23/65-97C 9 High St. Brookeville
(Brookeville Historic District)

SUBJECT: Historic Area Work Permit

HISTORIC PRESERVATION COMMISSION STAFF REPORT

PROPOSAL: Remove existing porch;
construct new front porch.

9
 21

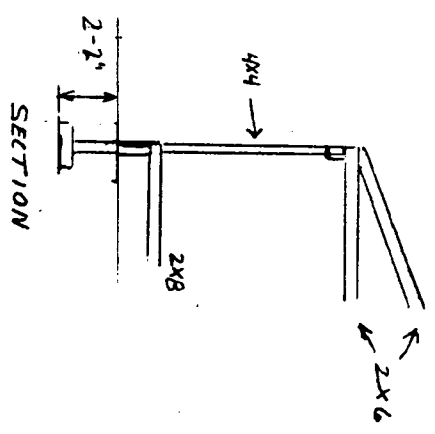
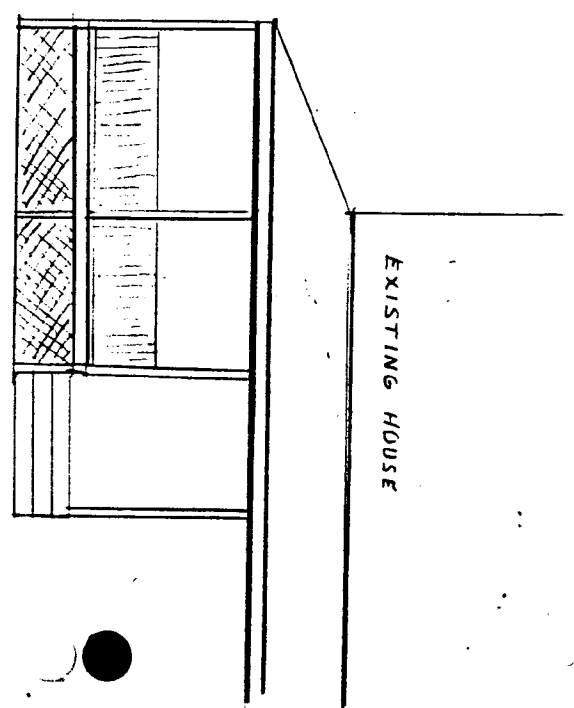
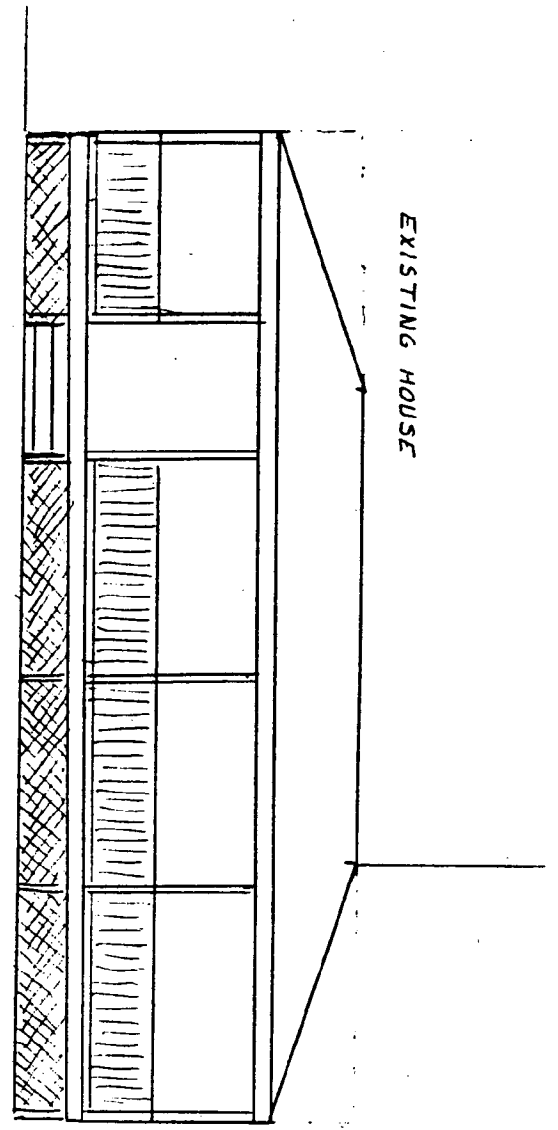
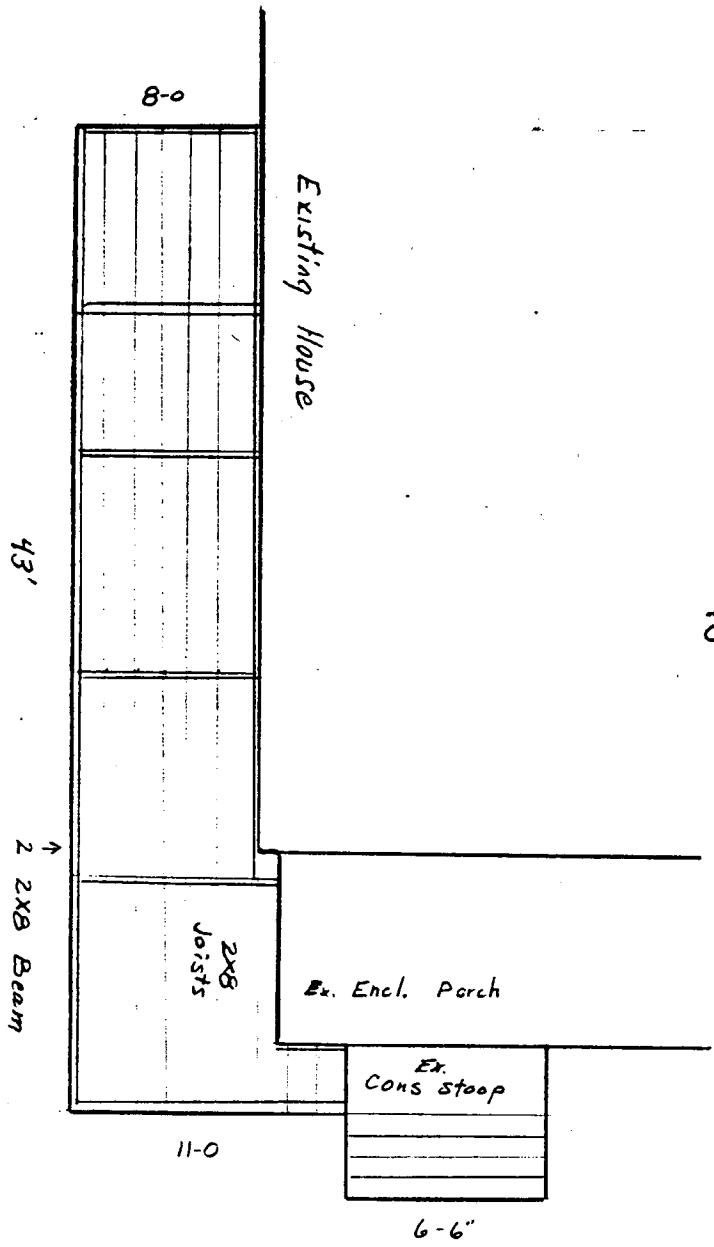
Staff notes that there is some discrepancy in the drawings with regard to the corner where the sun porch is located. The plan, as shown on Circle 10, does not show the roof as contiguous with the existing sun porch roof. This is shown, however, in the elevation drawing on Circle 9. The applicant should re-examine this corner, and work out this discrepancy.

1. Before the HAWP is transmitted to DPS, the applicant will provide for staff review detailed drawings of the proposed porch, including specifications for the porch columns, the porch ceiling, the porch floor, and the porch railing.
2. The new porch columns will be similar in design to the existing columns.
3. The porch railing will utilize inset pickets.
4. The porch floor will utilize typical tongue and groove flooring running perpendicular to the house.
5. All new wood surfaces will be painted.
